# CITY OF ALBUQUERQUE

**RE: Signal Village Subdivision  
Signal and Ventura NE  
Grading Plan Stamp Date: 2/20/19  
Drainage Report Stamp Date: 2/20/19  
Hydrology File: C20D078**

**Re: Signal Village Subdivision Grading Plan and Drainage Report (C20D078)**

SHEET No.  
**C501**

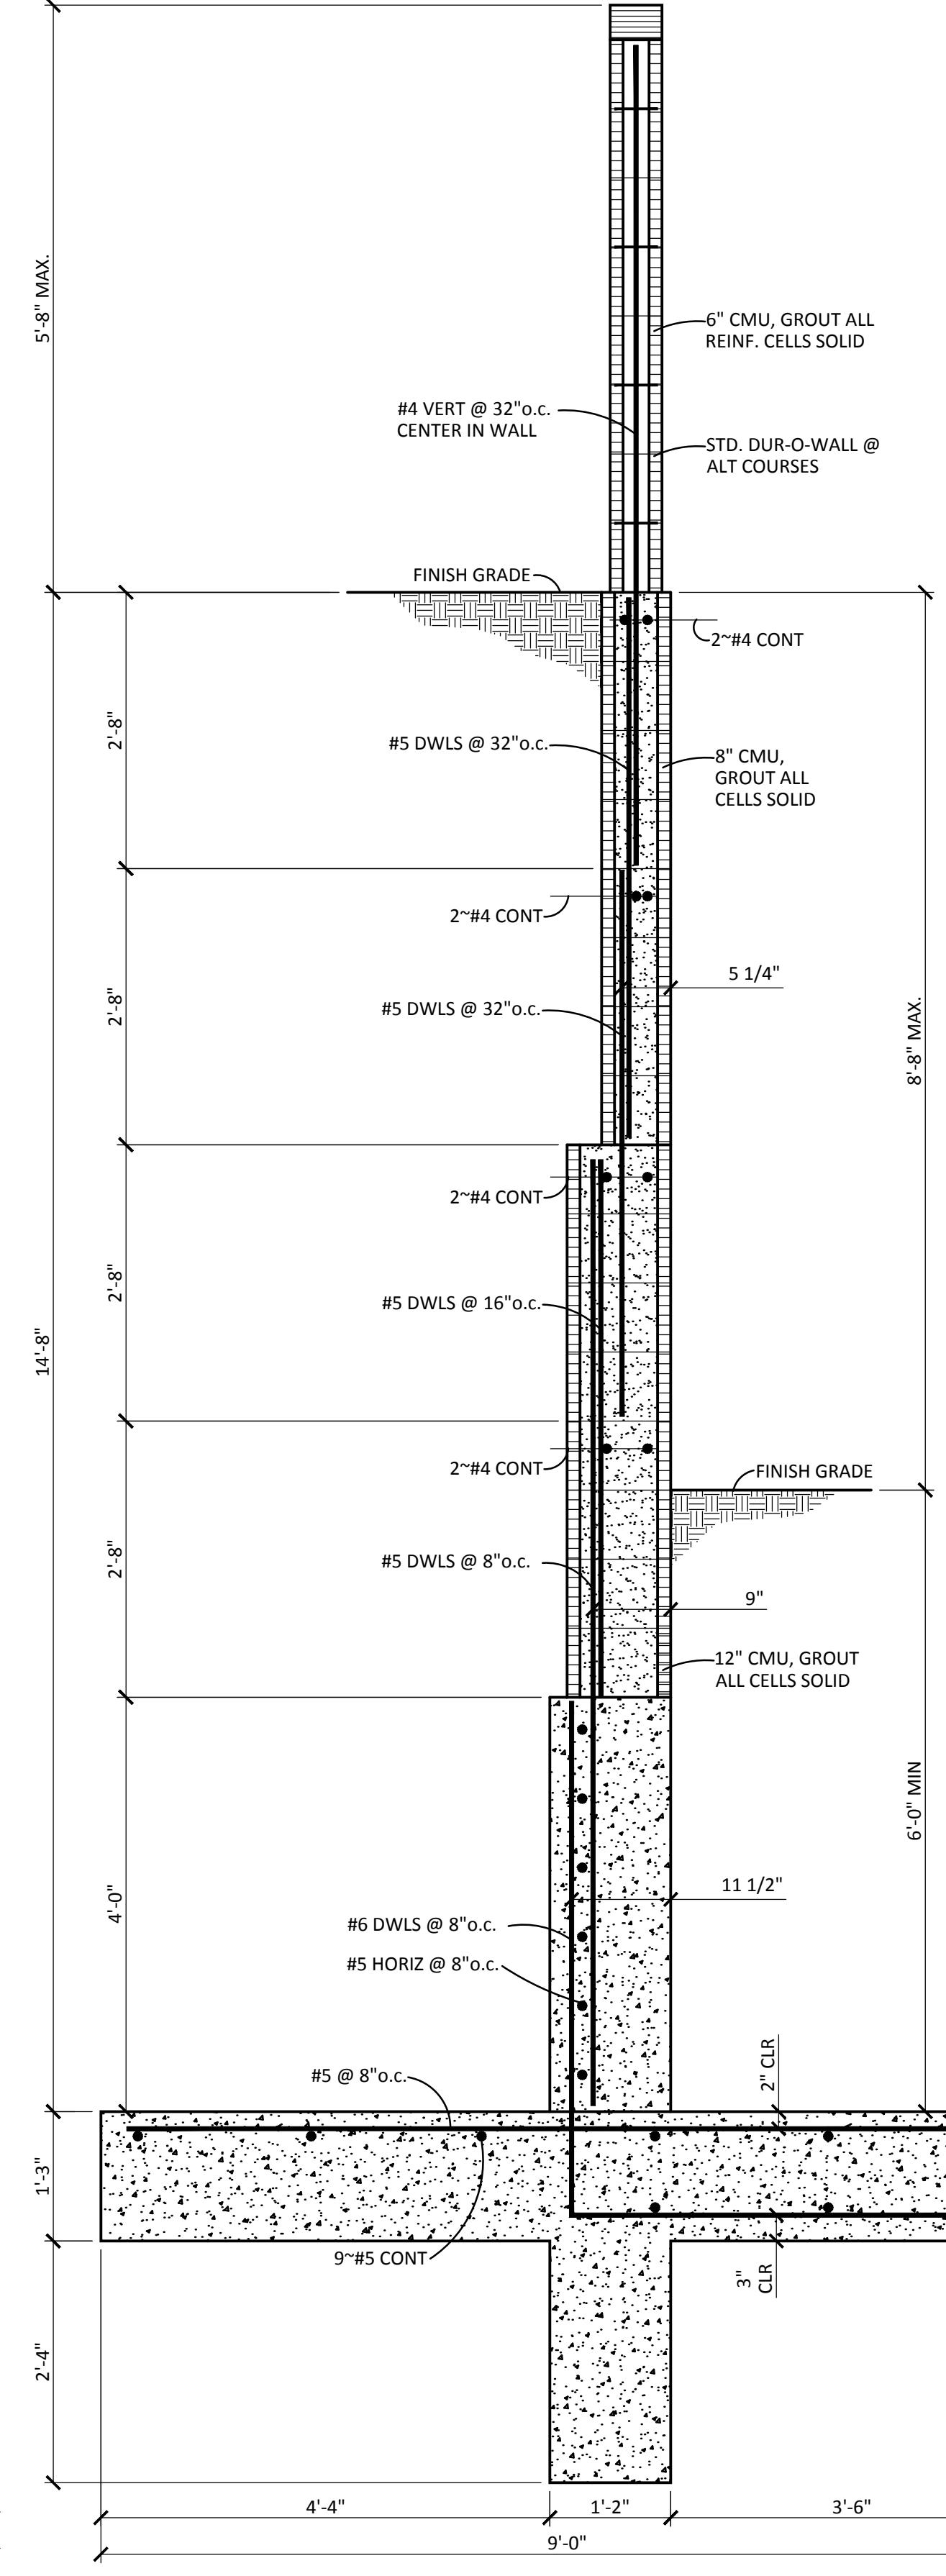
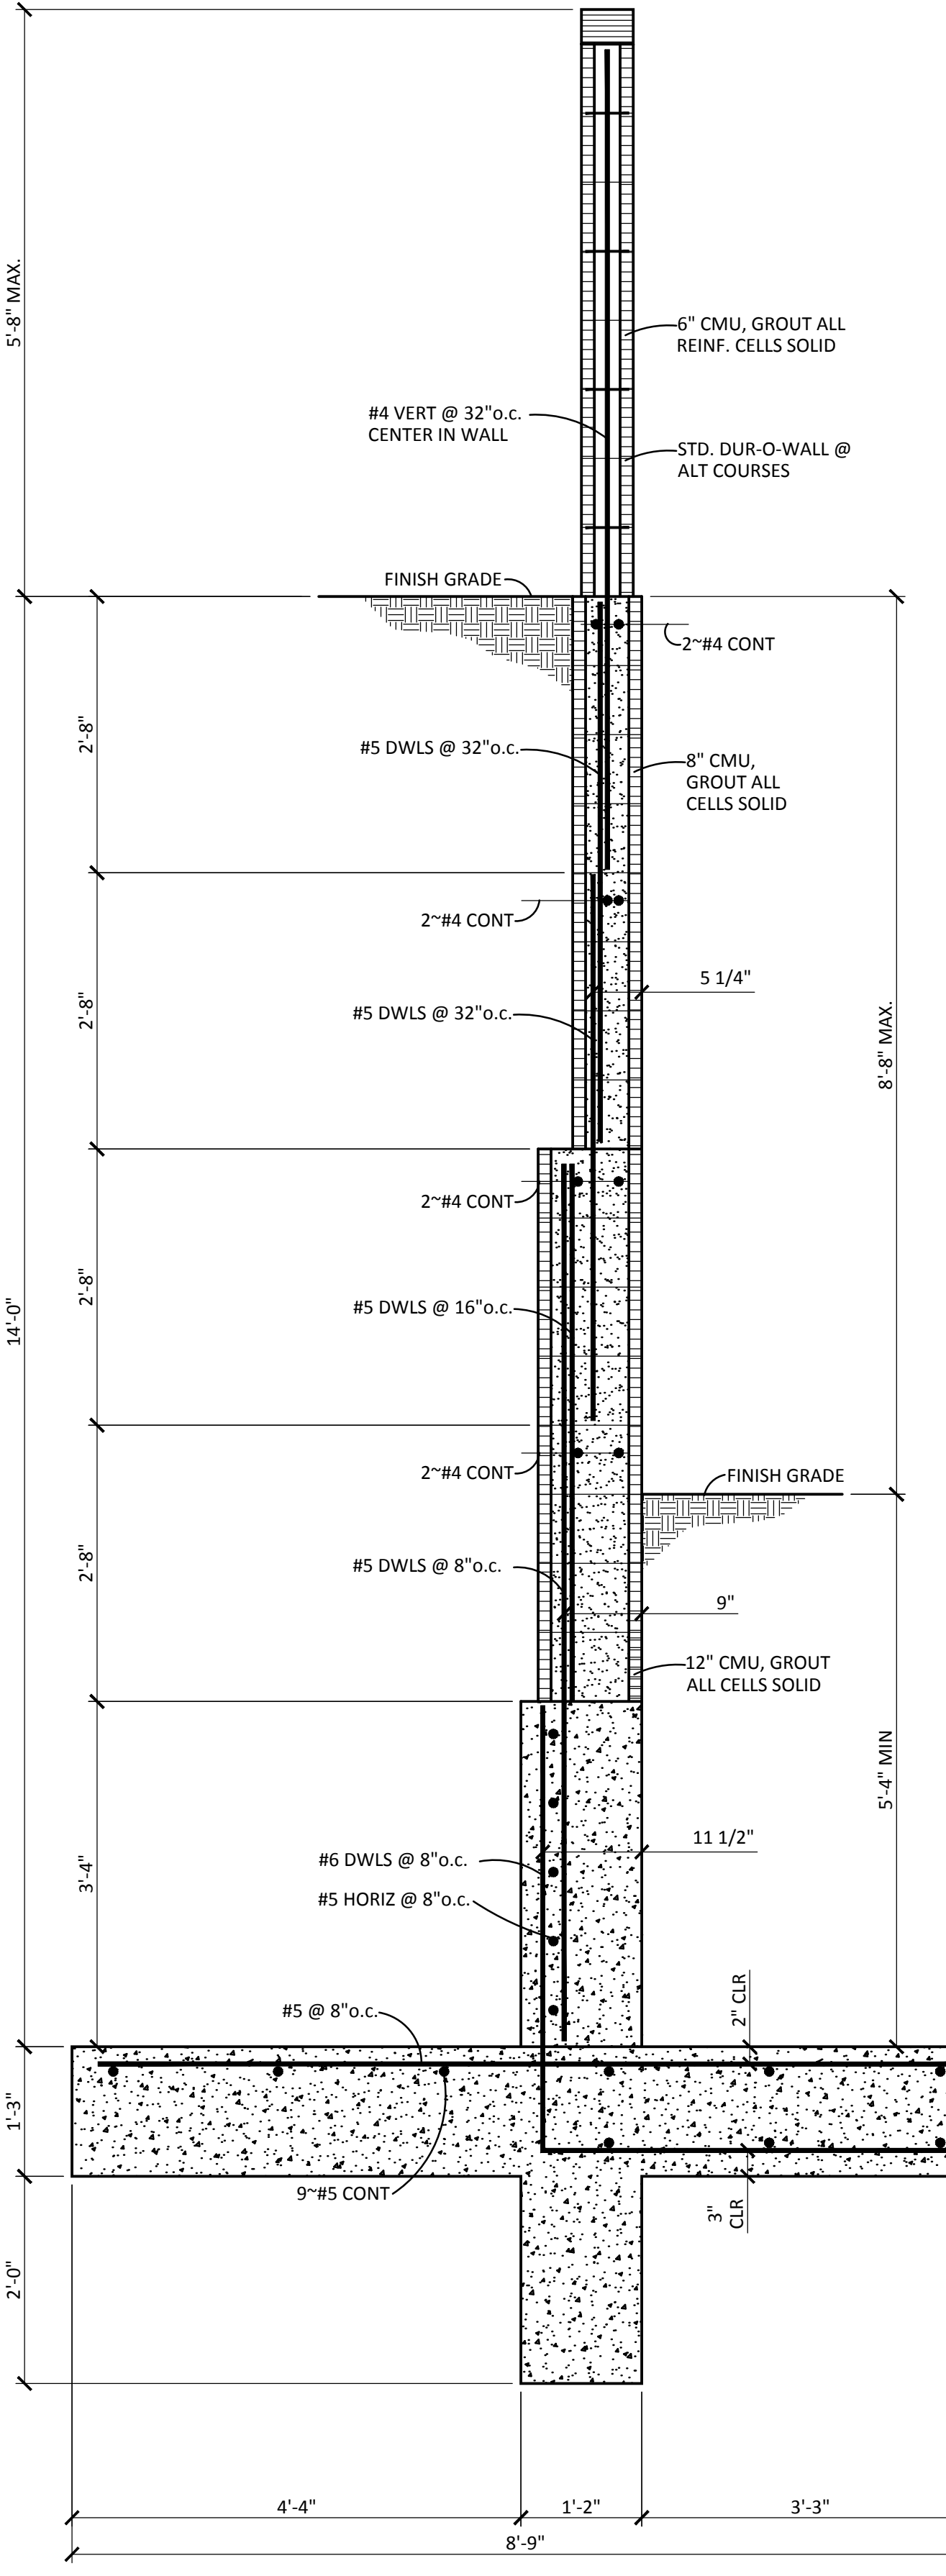
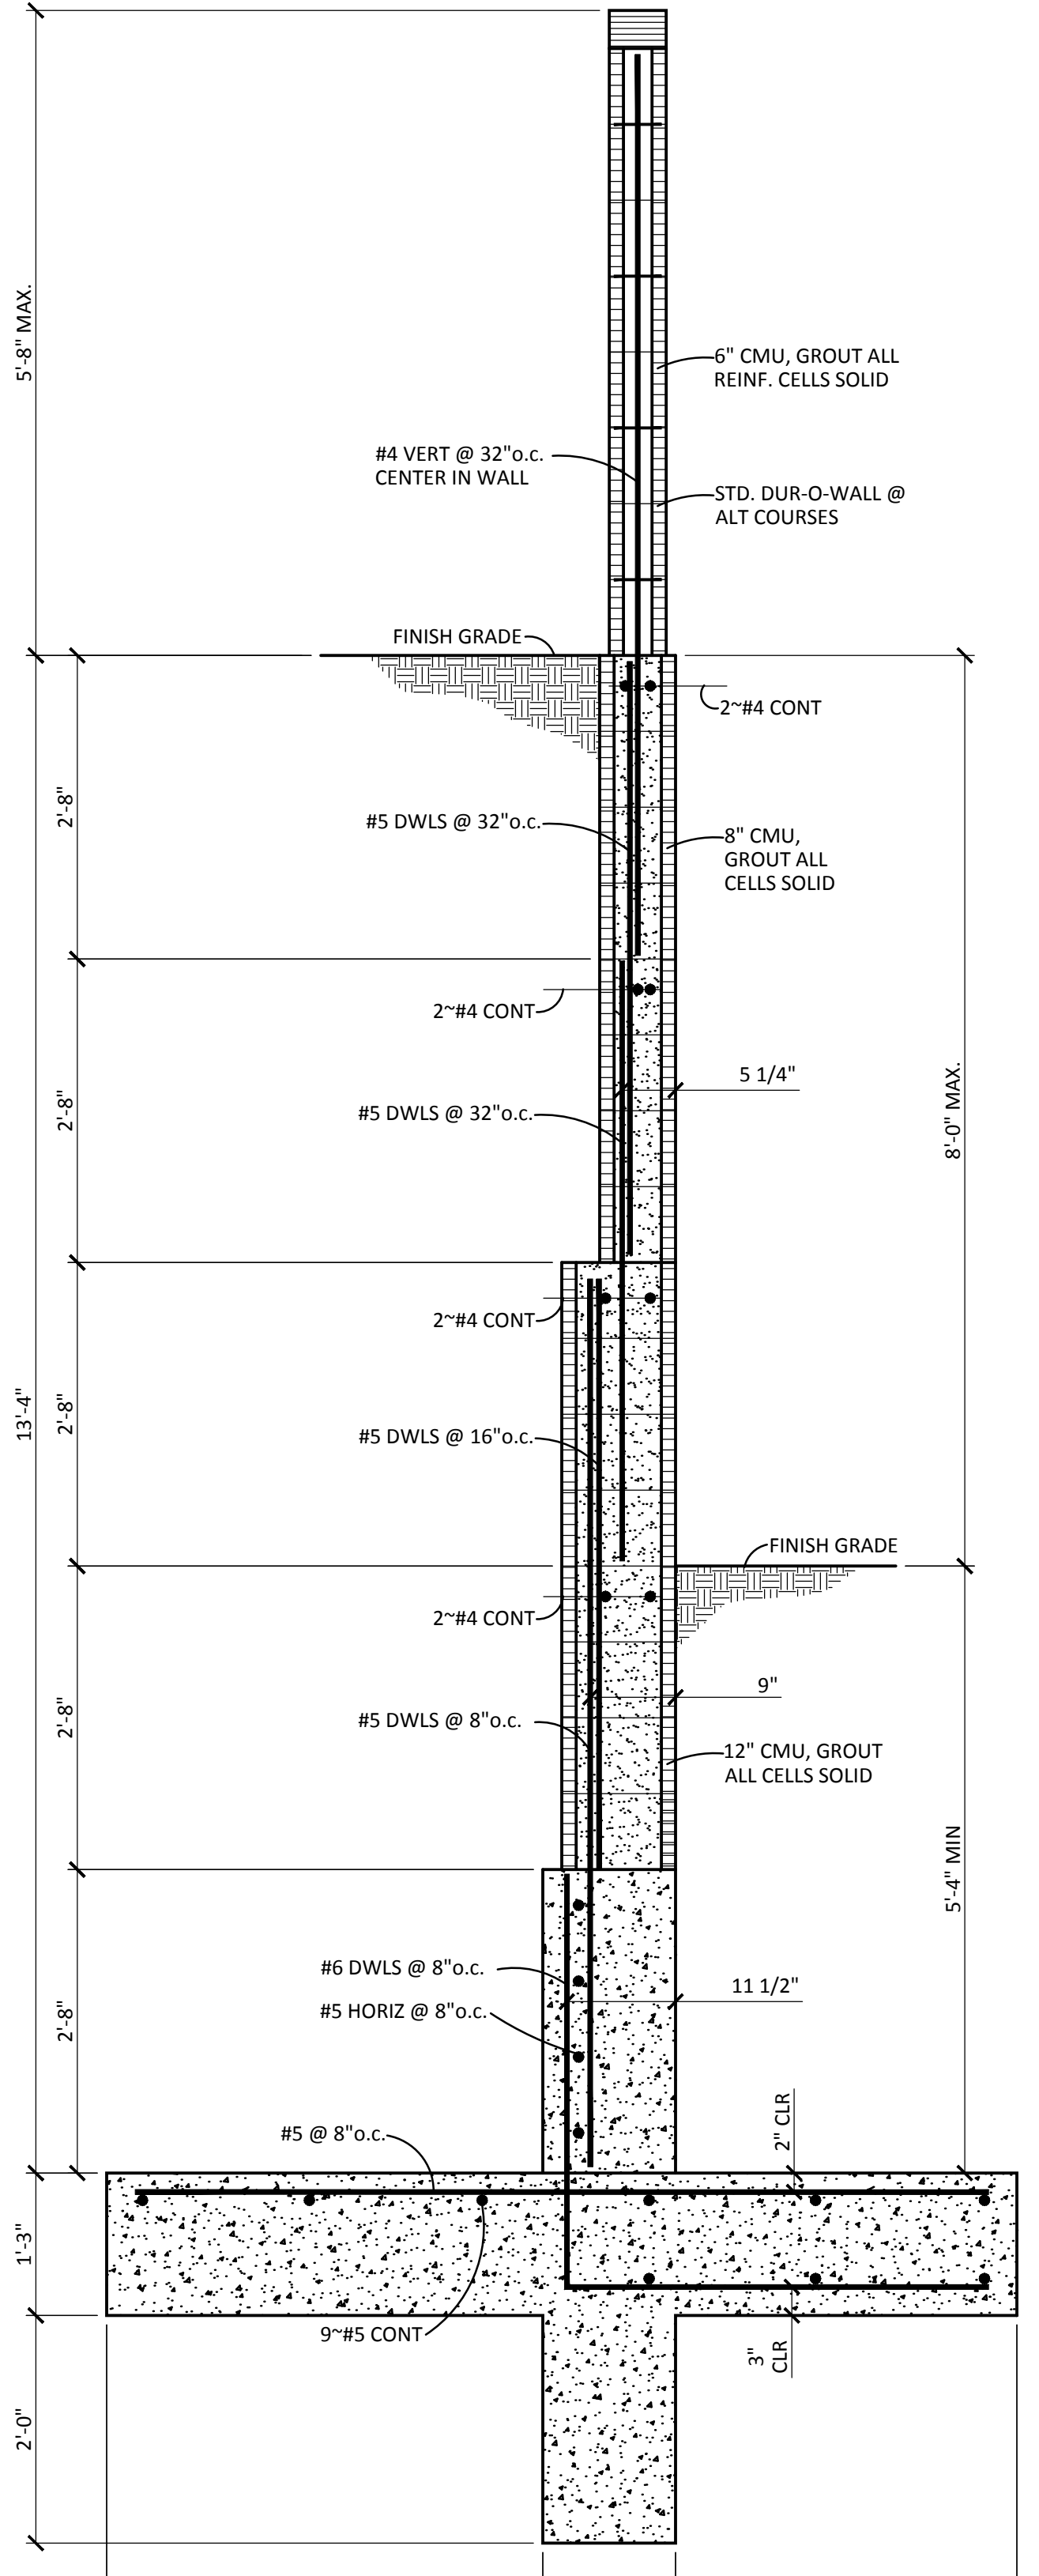
- c. The section of the channel on the west property line is incomplete on sheet C501. It should also show the existing grade on both sides of the existing wall with horizontal and vertical dimensions to the property line and the new retaining wall /channel. The channel, new retaining wall, existing wall, and property line need to be clearly shown on the plan and profile on sheet C105.

- d. The street sections on sheet C501 are not consistent with what is shown on the G&D Plan and on the infrastructure list. Signal Ave is to have a 32' FF roadway but it is mislabeled 30' on the G&D Plan and on the section. The onsite road is 24' FF offset to one side to accommodate sidewalk on the north side but the sidewalk is missing on the section and on the G&D Plan. All elements of the roadway, sidewalk and easement must have dimension ties to the property line on both the section and the G&D Plan.
